**Re: Contract No. HY/2010/08
Central – Wan Chai Bypass – Tunnel (Slip Road 8 Section)
Additional Mitigation Plan for Slip Road 8 (Rev. 4)**

Additional Mitigation Plan for Slip Road 8 (Revision 4)

Additional Mitigation Plan for Slip Road 8 under condition 2.16 of FEP- 10/364/2009/B

Revision: 4

TITLE: VICTORIA PARK REPROVISIONING IRRIGATION SYSTEM LAYOUT PLAN

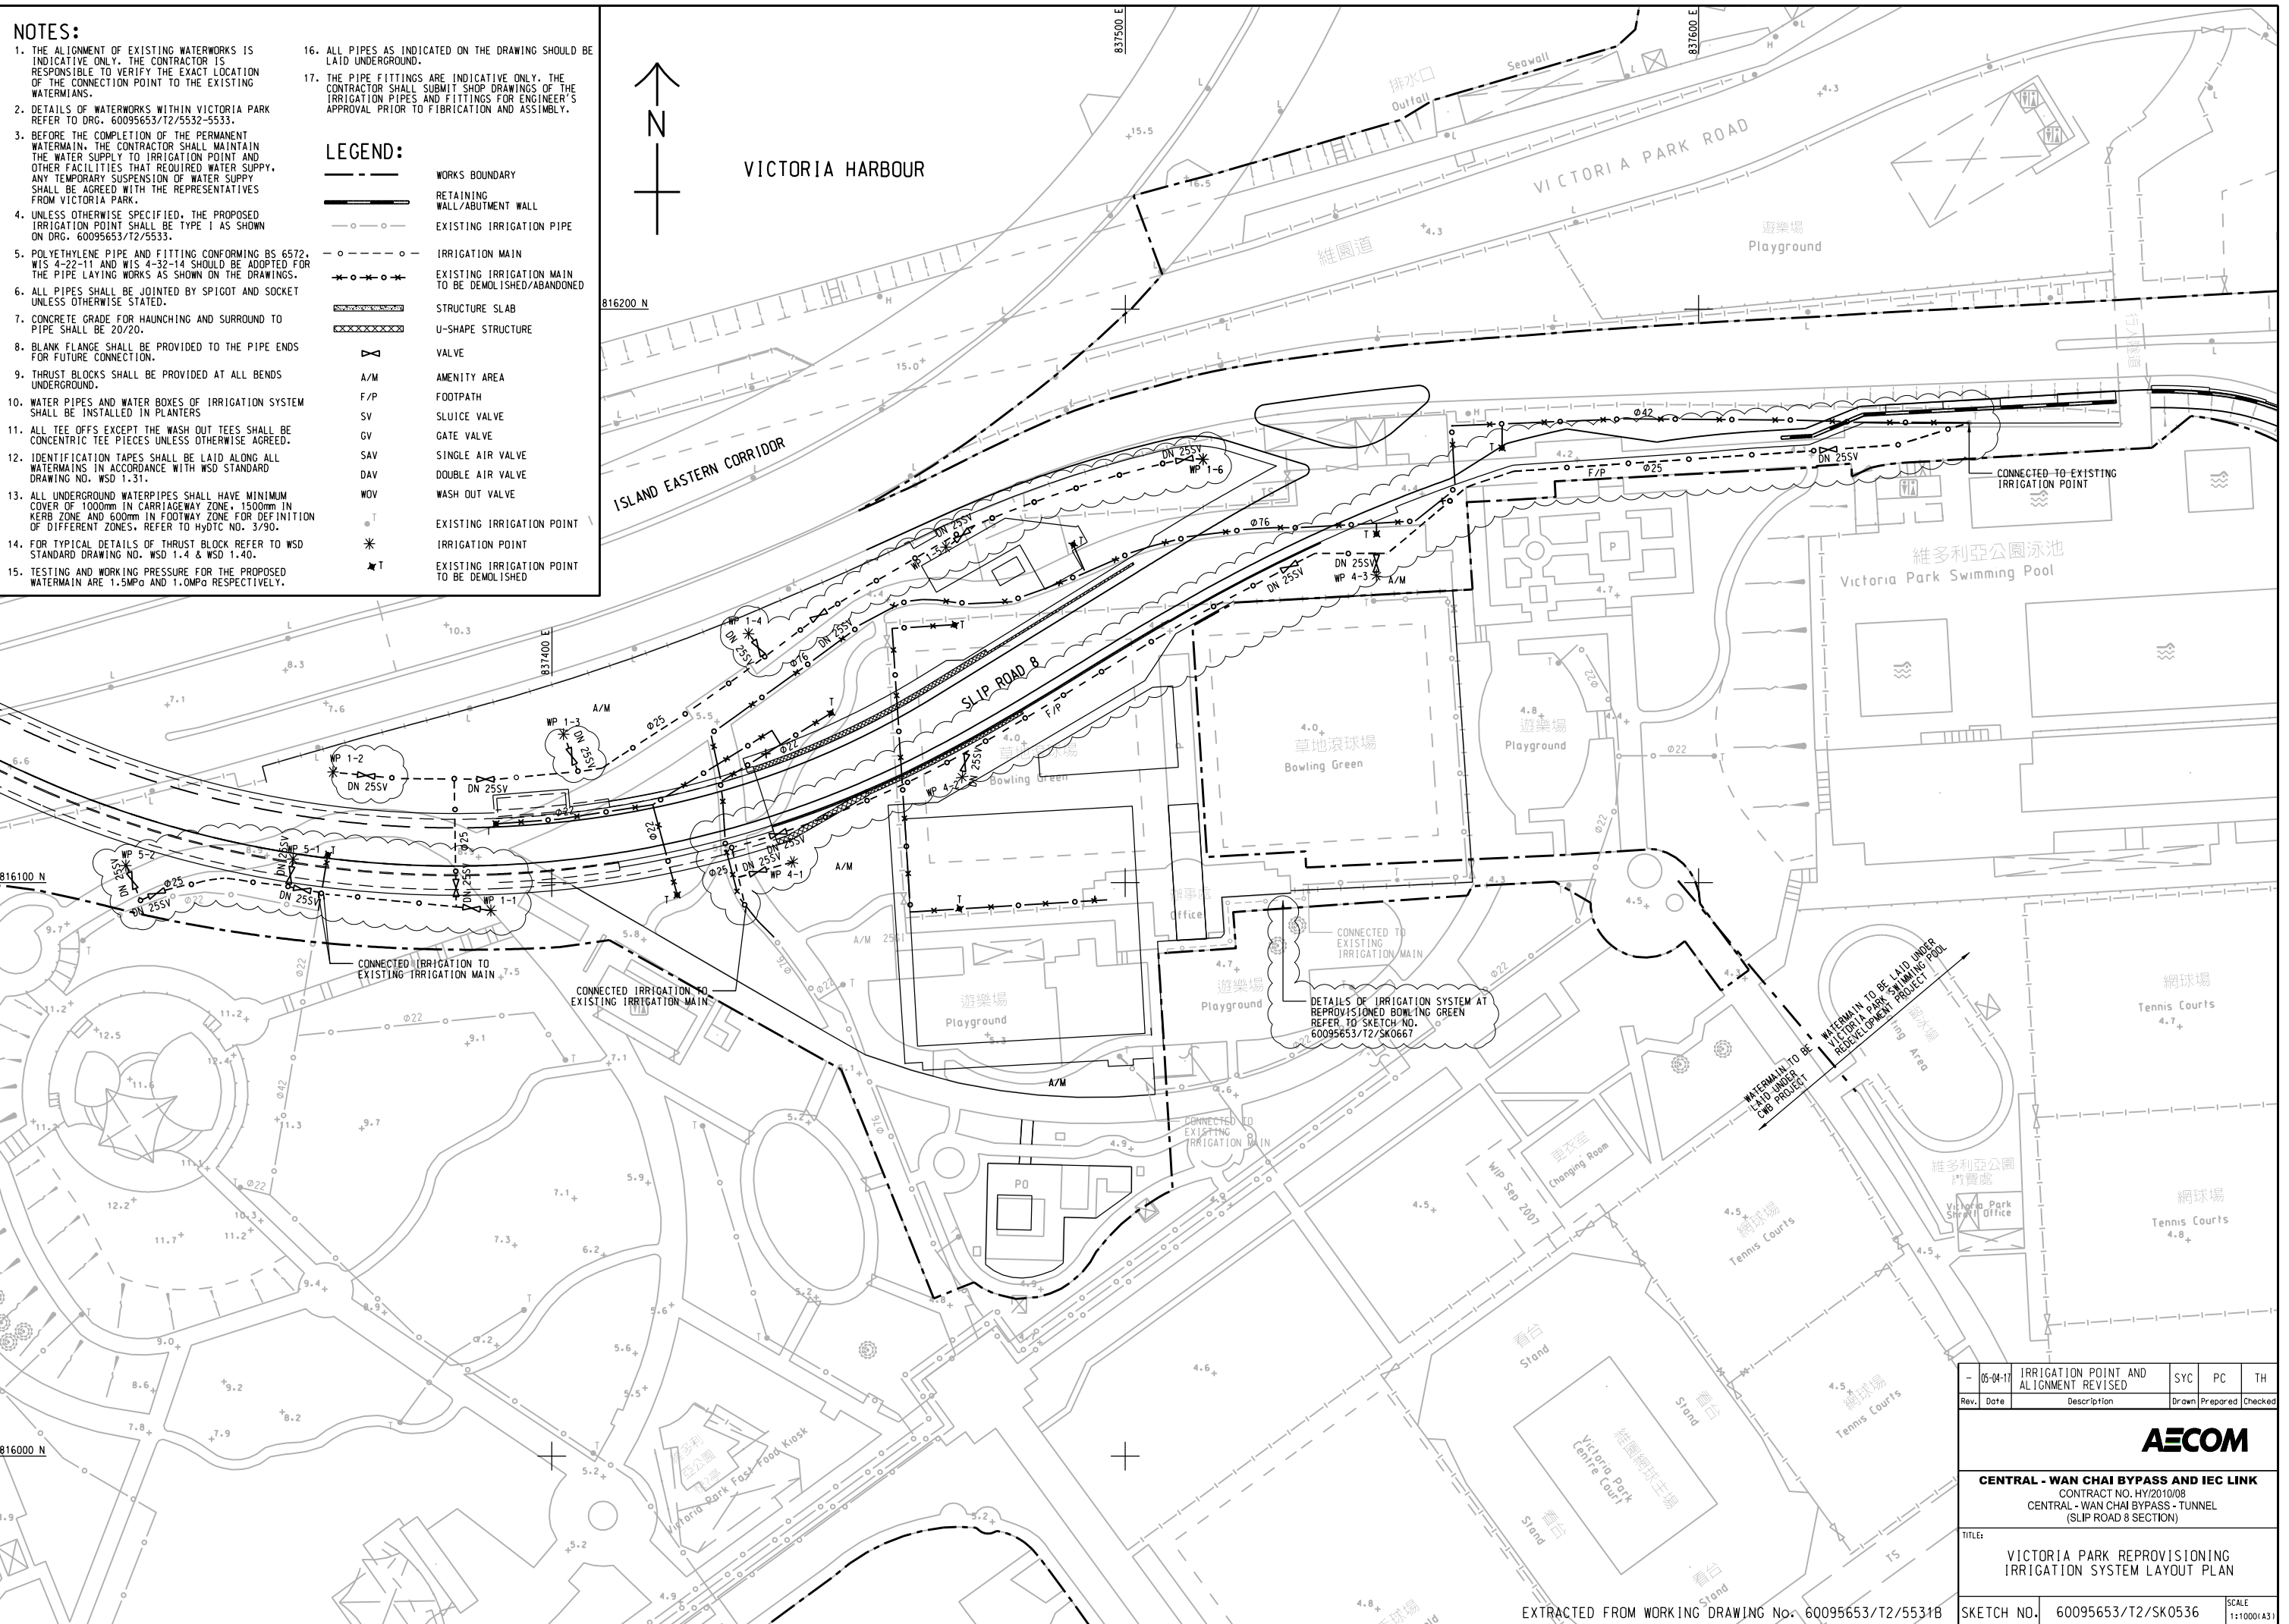
<ul style="list-style-type: none"> • Details to support the proposed bamboo planting, e.g. width and depth of soil medium and irrigation arrangement should be indicated in the section A-A drawing. 	For the width of the soil medium please refer to the site sketch as attached in Appendix C . For the depth of the soil medium, it varies from 1.7m to 4.5m. For the irrigation arrangement layout and details of waterpoint, please refer to the site sketch as attached in Appendix E .
